**CAMDEN FAMILY HEALTH, INC.
NICHOLAS COUNTY, WEST VIRGINIA
CAMDEN-ON-GAULEY RICHWOOD CLINIC**

ADDENDUM #4

July 11, 2022

THRASHER PROJECT #060-10260

SHEET No. **A1.01**

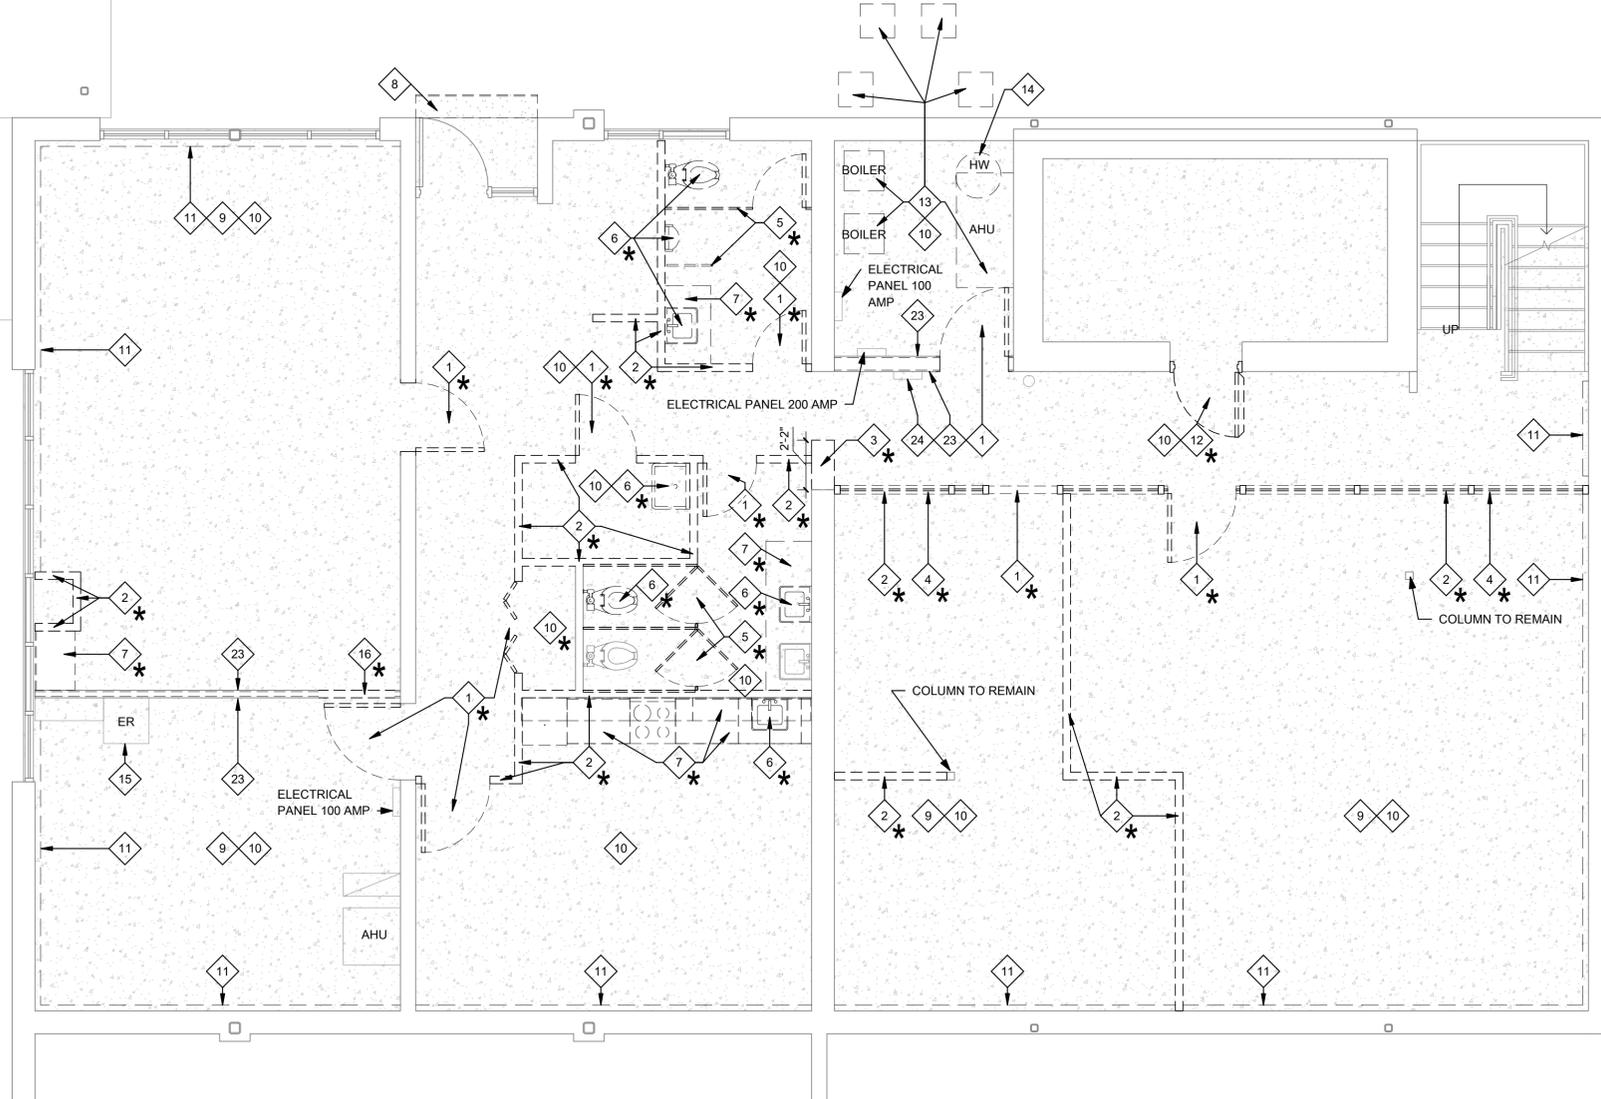
3. On Sheet #A1.01, please clarify Demo Keyed Note #8 "Remove or Construct on Top of Existing Stair". Is the intent to replace with a ramp, etc.?

Sheet Keynote #8 shall be omitted.

1 GROUND FLOOR PLAN - NEW
 1/4" = 1'-0"

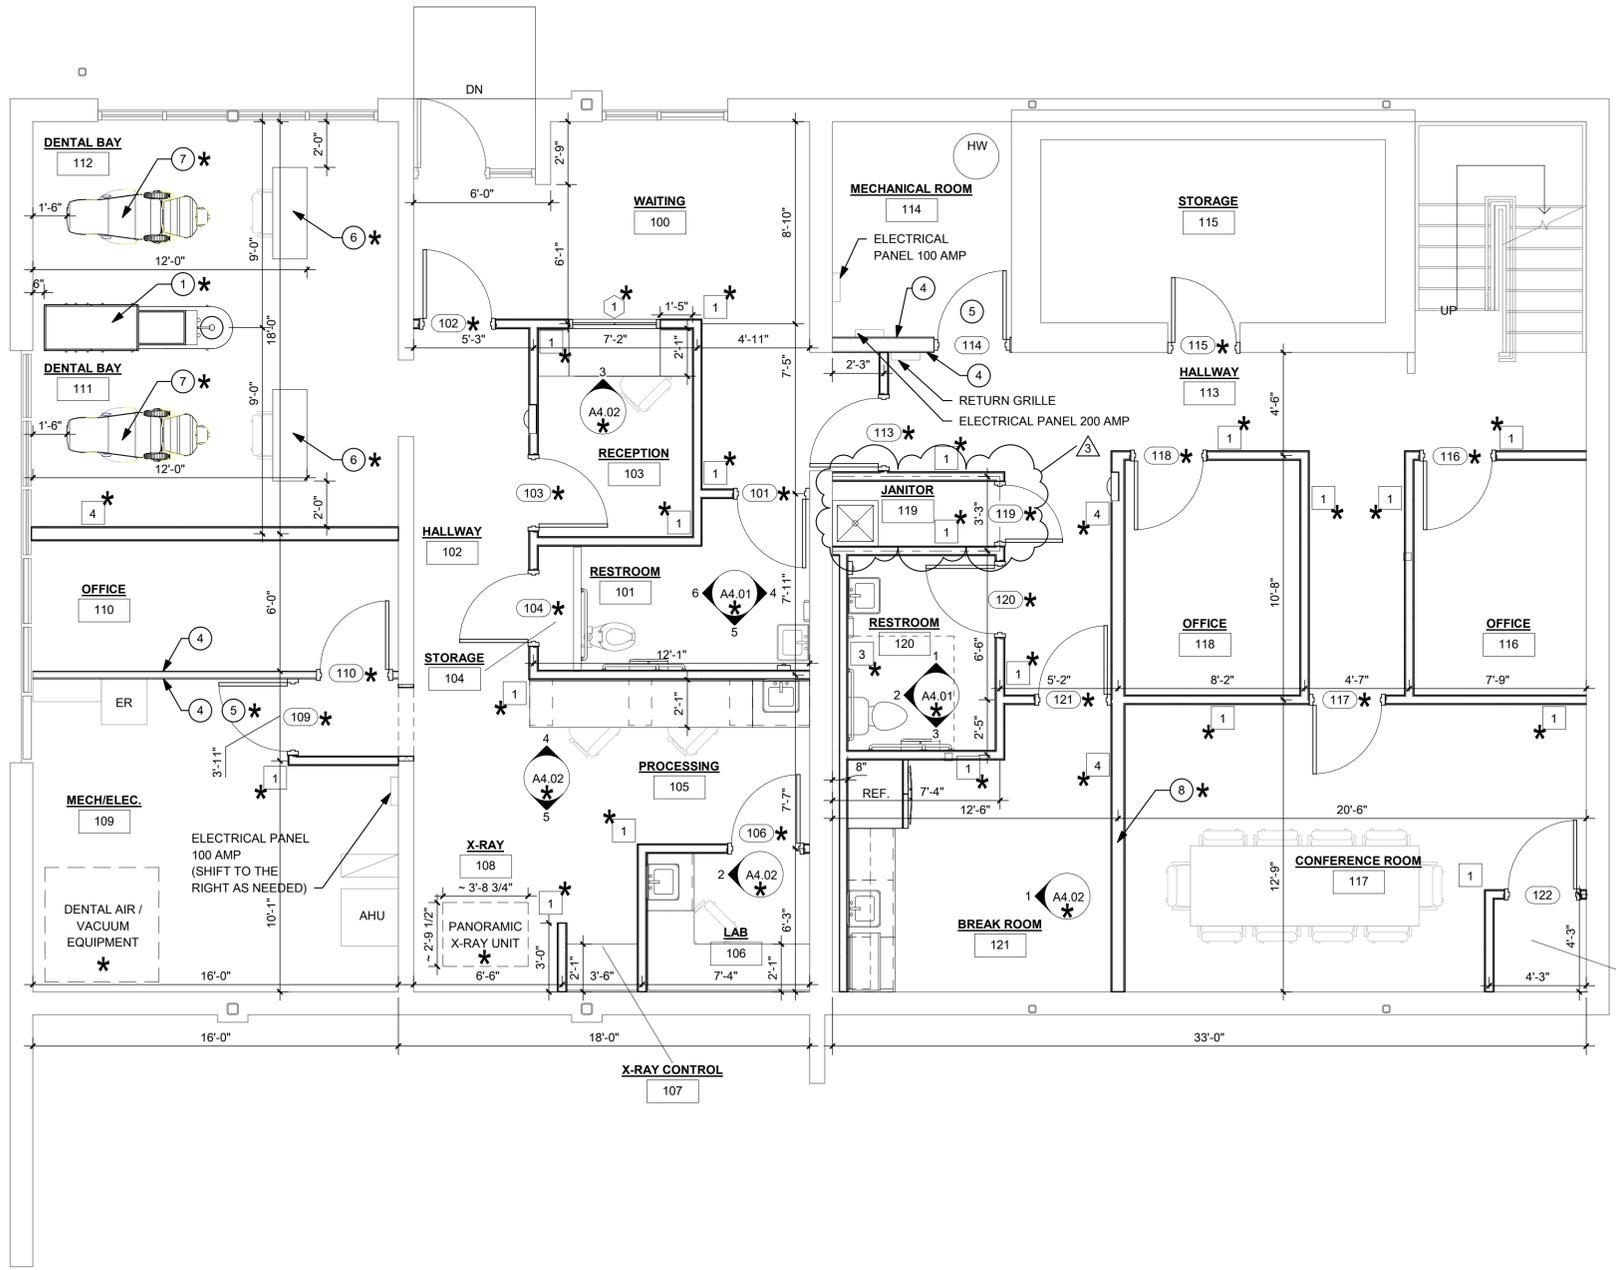
PER THE WV STATE FIRE MARSHAL REVIEW, PROVIDE 1-HOUR RATED FIRE BARRIER AT JANITOR CLOSET 119. PARTITION ASSEMBLY SHALL CONSIST OF 5/8" TYPE X GYPSUM BOARD ON EACH SIDE OF METAL FRAMING. PARTITIONS SHALL GO UP TO DECK. CEILING SHALL BE TWO LAYERS OF 5/8" TYPE X GYPSUM BOARD. ALL PENETRATIONS SHALL BE FIRESTOPPED WITH APPLICABLE PRODUCTS. DOOR 119, FRAME, AND HARDWARE SHALL BE FIRE-RATED (45-MIN). MECHANICAL EQUIPMENT SHALL INCLUDE FIRE DAMPERS WHERE DUCTS PENETRATE THE FIRE BARRIERS. SCOPE IS FOR ALTERNATE #1.

1 FIRST FLOOR PLAN - NEW
1/4" = 1'-0"

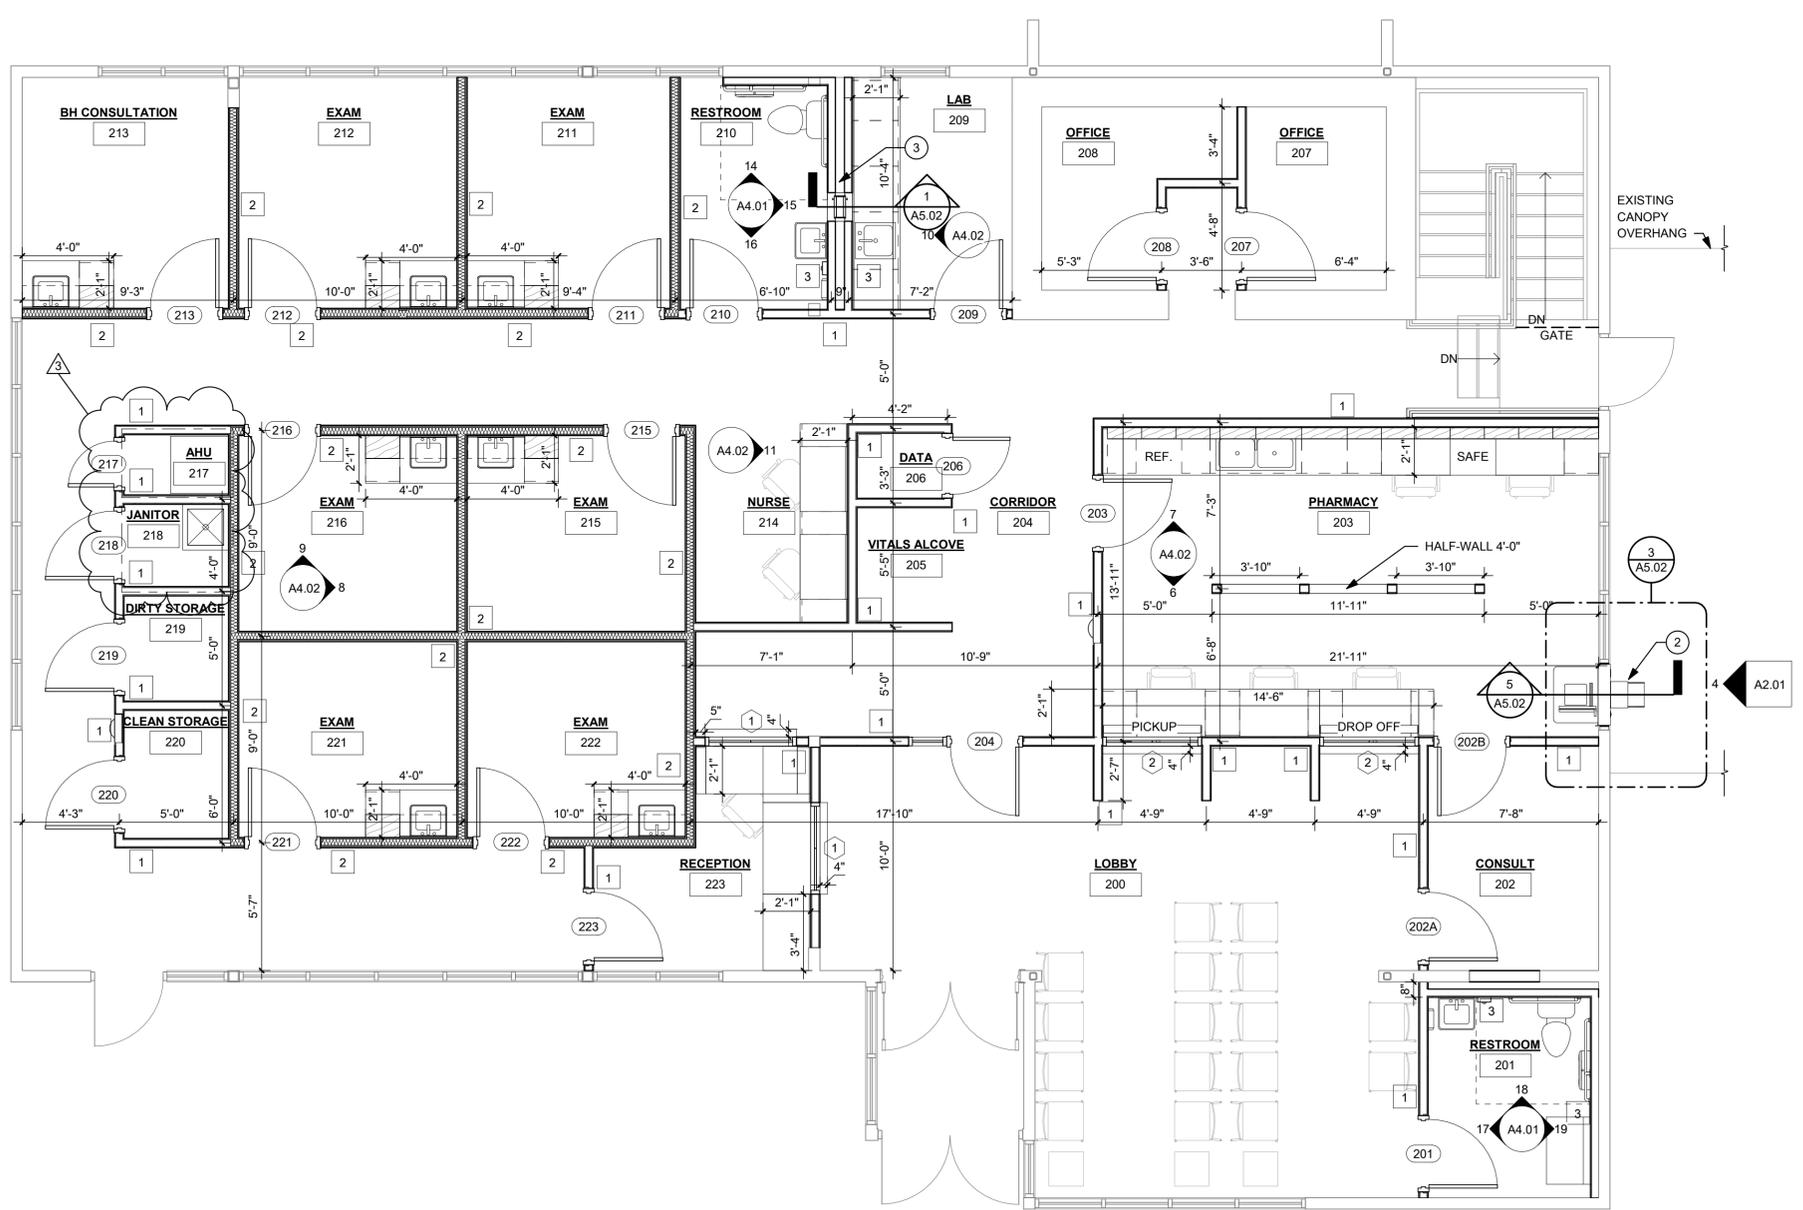
1. In response to WV State Fire Marshal review, the plan reviewer (C. Cummings) was notified that rooms #219 and #220 were not used for the storage of hospital linens. Per this response, the Plan Reviewer eliminated the request that these rooms have 1-hour fire barrier separation."

PER THE WV STATE FIRE MARSHAL REVIEW, PROVIDE 1-HOUR RATED FIRE BARRIER AT AHU 217 AND JANITOR CLOSET 218. PARTITION ASSEMBLY SHALL CONSIST OF 5/8" TYPE X GYPSUM BOARD ON EACH SIDE OF METAL FRAMING. PARTITIONS SHALL GO UP TO DECK. CEILING SHALL BE TWO LAYERS OF 5/8" TYPE X GYPSUM BOARD. ALL PENETRATIONS SHALL BE FIRESTOPPED WITH APPLICABLE PRODUCTS. DOOR 217 AND 218, FRAME, AND HARDWARE SHALL BE FIRE-RATED (45-MIN). MECHANICAL EQUIPMENT SHALL INCLUDE FIRE DAMPERS WHERE DUCTS PENETRATE THE FIRE BARRIERS.

1
A1.05
GROUND FLOOR REFLECTED CEILING PLAN - NEW
1/4" = 1'-0"

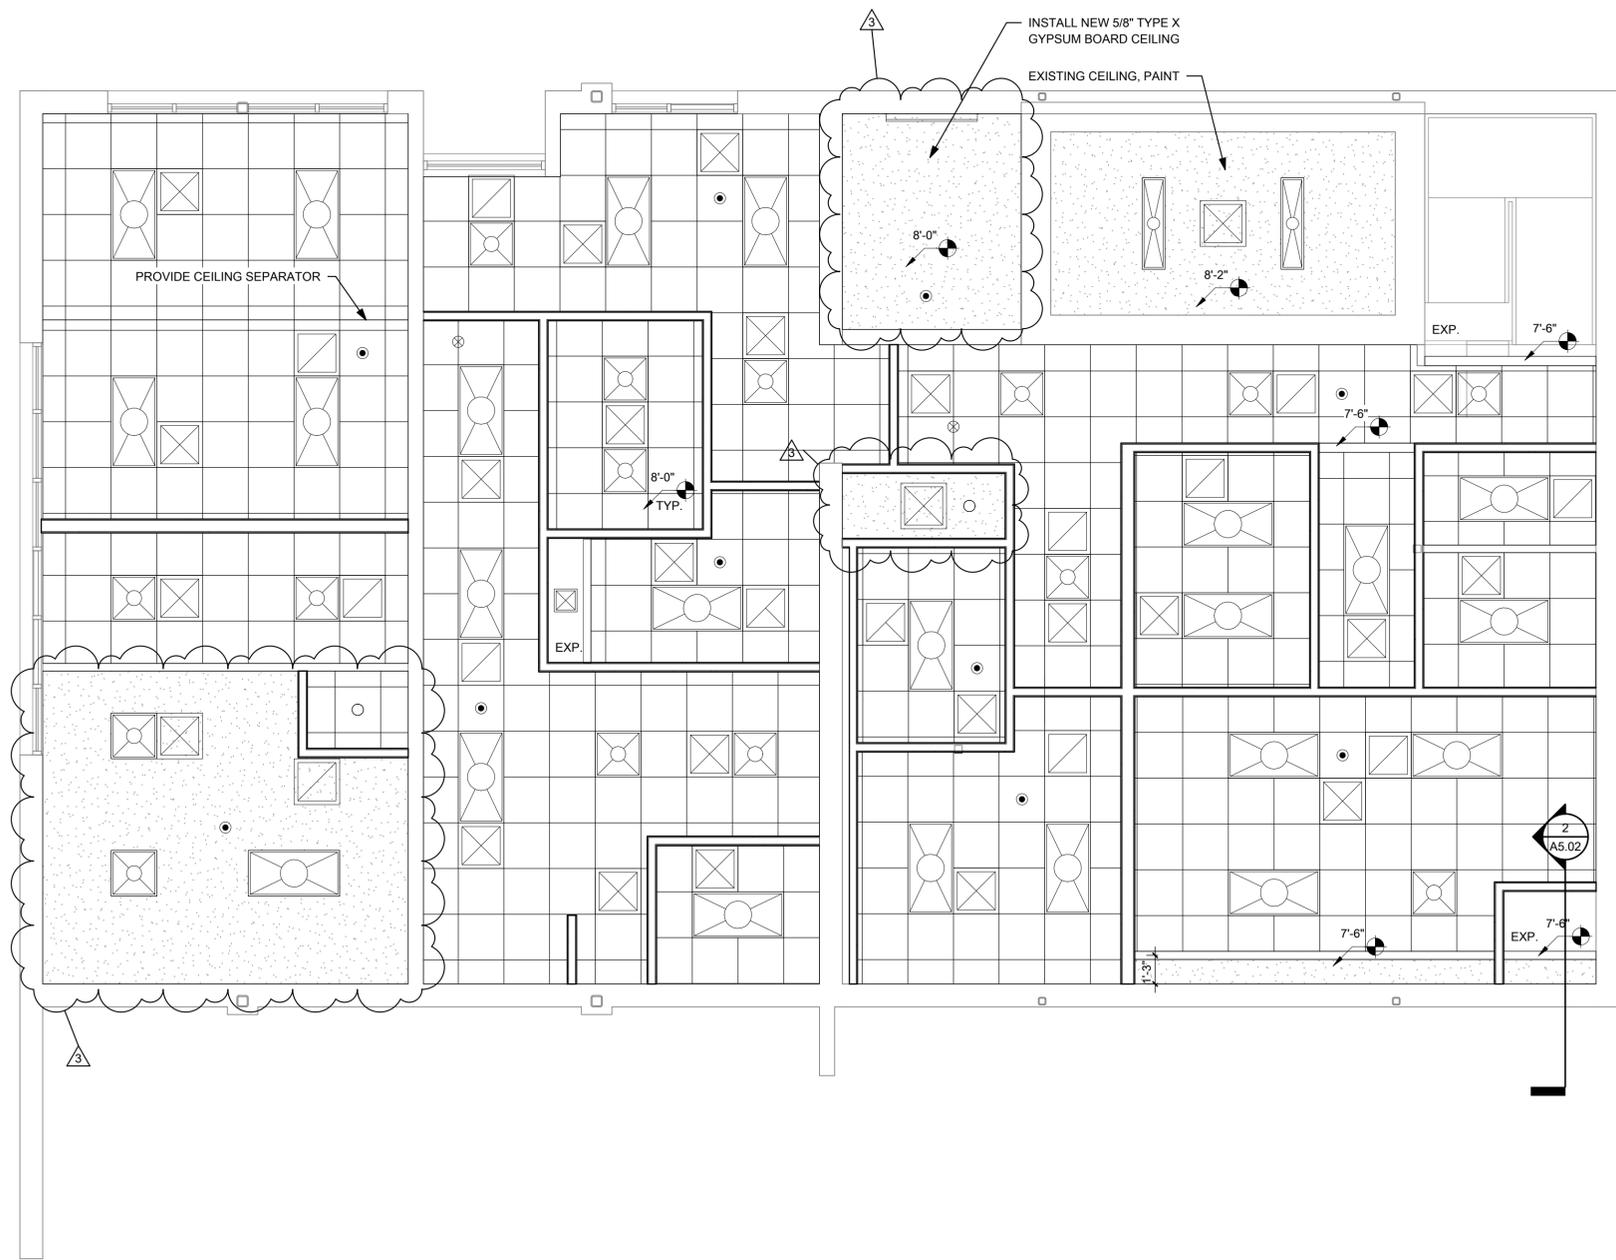
2. According to the Finish Schedule, Ground Floor Room #122 "Water Utility Room" is included in the base bid. Ground Floor RCP shows a bulkhead in this room and Addendum #3 stated that new bulkhead is a part of Alternate #1. Does this apply to Room #122?

PER THE WV STATE FIRE MARSHAL REVIEW, AT MECHANICAL ROOM 109, MECHANICAL ROOM 114, AND JANITOR 119 APPLY TWO LAYERS OF 5/8" TYPE X GYPSUM BOARD FOR CEILING. ALL PENETRATIONS SHALL BE FIRESTOPPED WITH APPLICABLE PRODUCTS. MECHANICAL EQUIPMENT SHALL INCLUDE FIRE DAMPERS WHERE DUCTS PENETRATE PARTITIONS DIVIDING MECHANICAL ROOM 109, MECHANICAL ROOM 114, AND JANITOR 119. ALL SCOPE OF WORK FOR JANITOR 119 IS PART OF ALTERNATE #1.

The bulkhead is not needed in the Water Utility Room. The plumbing can remain exposed in this location.
